QUALITY AUDIT

Title: **QUALITY AUDIT**
For;
Proposed Moygaddy Castle SHD

Report reference: **1577R01**

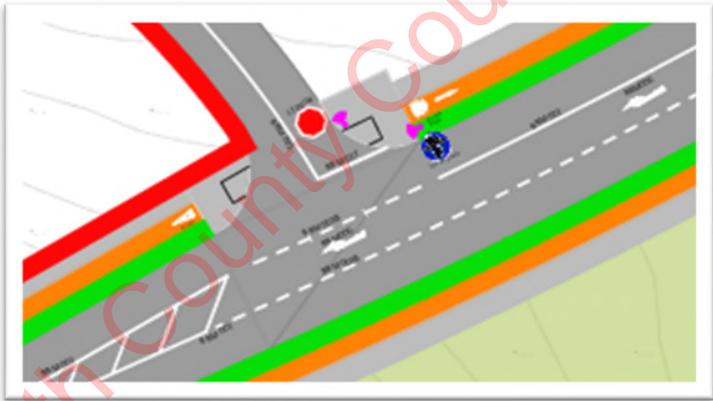
3.1 Issue

Drawing S665-OCSC-1C-MH-DR-C-0111 S4 P04, MOOR

Both junctions on the MOOR extension are simple priority junctions. There are no facilities for pedestrians or cyclists to cross from one side to the other.

It is recommended that crossing facilities be provided for vulnerable road users.

3.1	Yes	Yes	Toucan Crossing to be added with Detailed design on the MOOR north of the junction with the L6219 (Eastern)	Yes
3.2	Yes	No	The red line has been adjusted to take account of verge requirements for forward visibility. Pedestrian and cyclist infrastructure will be provided along this road as part of the future development of this part of the masterplan lands.	Yes

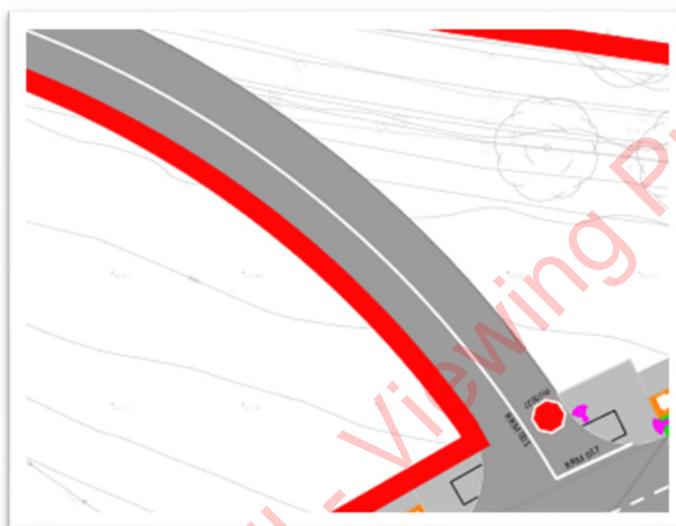
3.2 Issue

Drawing S665-OCSC-1C-MH-DR-C-0111 S4 P04, MOOR

The tie-in with the existing L2214-3 and the realigned L2214-3 is shown to be constructed tight to the land boundary. This may leave no room for refuge in a verge or footpath for pedestrians. This could lead to collisions with vehicular traffic,

It is recommended that that a suitable verge width be provided.

It is also recommended that the footpaths be returned around the sideroad of the junction of the western tie-in as far as a suitable transition point for transfer to on-road pedestrians.

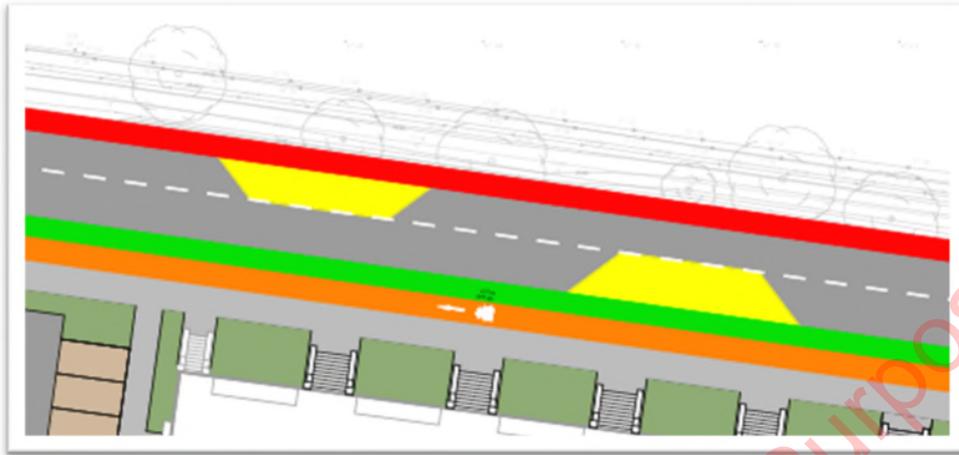
3.3 Issue

S665-OCSC-1C-MH-DR-C-0111 S4 P04, MOOR & L2214-3

At both junctions on the extended MOOR and on the junctions along the improved L2214-3 cyclists have to yield to sideroad traffic. This could make the cycle facilities unattractive to cyclists due to journey time delays. Cyclists may opt to remain on the carriageway where they would have a higher likelihood of being struck by passing or turning vehicles.

It is recommended that the cycle tracks be transitioned to an on-road facility at the junctions and be clearly highlighted to alert drivers of their presence.

3.3	Yes	No	OCSC notes that there are several suitable solutions that will not affect the extent of works. OCSC will agree a suitable solution in consultation with MCC for this and similar locations at detailed design stage.	Yes

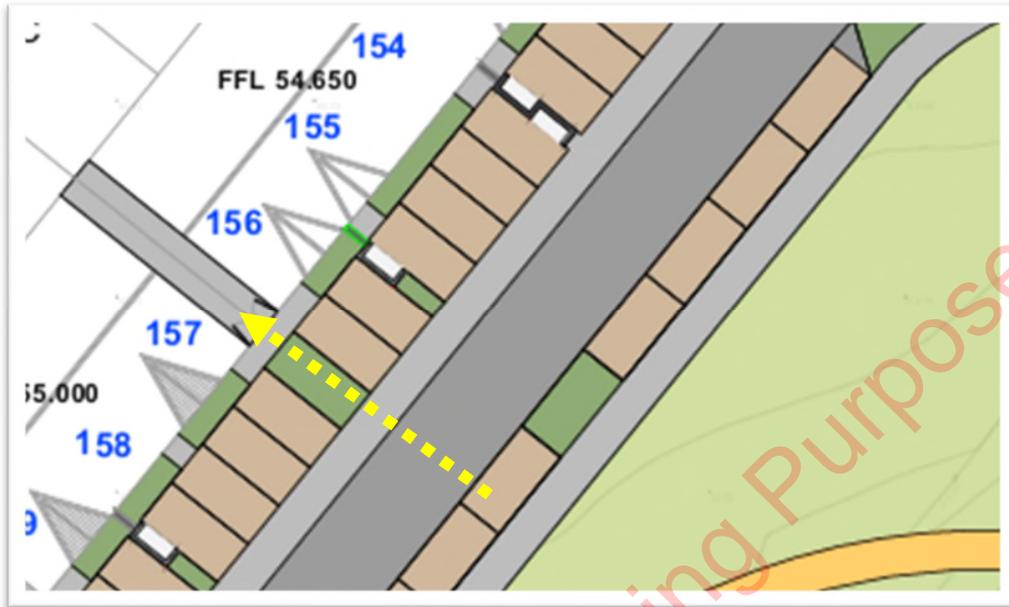
3.4 Issue

S665-OCSC-1C-MH-DR-C-0112 S4 P04, L2214-3

It is proposed to provide two chicanes on the L4413 as a means of providing traffic calming. It is anticipated that this will be a relatively heavily trafficked link/arterial road and this type of traffic calming may not be appropriate as approach speeds may be too high and this could lead to head on collisions.

It is recommended that more appropriate traffic calming measures be provided to suit the nature of the road.

3.4	No	No	The chicanes will not be installed until the MOOR is complete, and the purpose is to deter through vehicles from using the L6219 in favour of the MOOR.	Yes

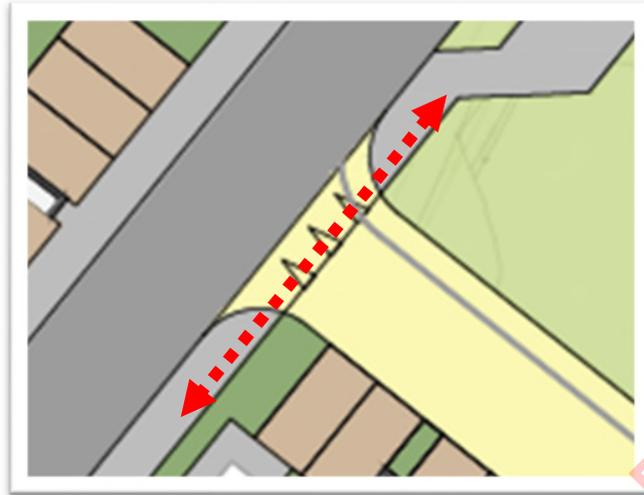
3.5 Issue

Throughout the development.

It is unclear if access to some residential units will be feasible for visitors if all the parking spaces are occupied. It appears that there are landscaped areas between parking spaces and along the front of the units.

It is recommended that access routes for pedestrians be provided assuming that all parking spaces are occupied.

3.5	Yes	Yes	The current driveway positions are wider than the required minimum as part of Part M. 1.2m access routes will be provided to all front doors as part of the Detailed Design stage of this development.	Yes

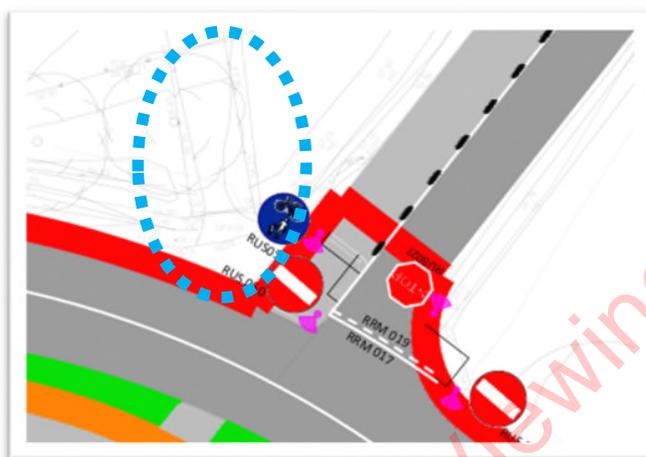
3.6 Issue

Throughout the development, Shared streets.

Shared streets are generally proposed to be raised to distinguish them from other streets. The tapers at some of the shared streets however coincide with the crossing area for pedestrians on the footpath. The steep gradients of the tapers could lead to instability for the mobility impaired and lead to falls.

It is recommended that the cross fall on the tapers be acceptable for all pedestrians users.

3.6	Yes	Yes	Taper length to be adjust as part of detailed design stage to be acceptable for pedestrians.	Yes
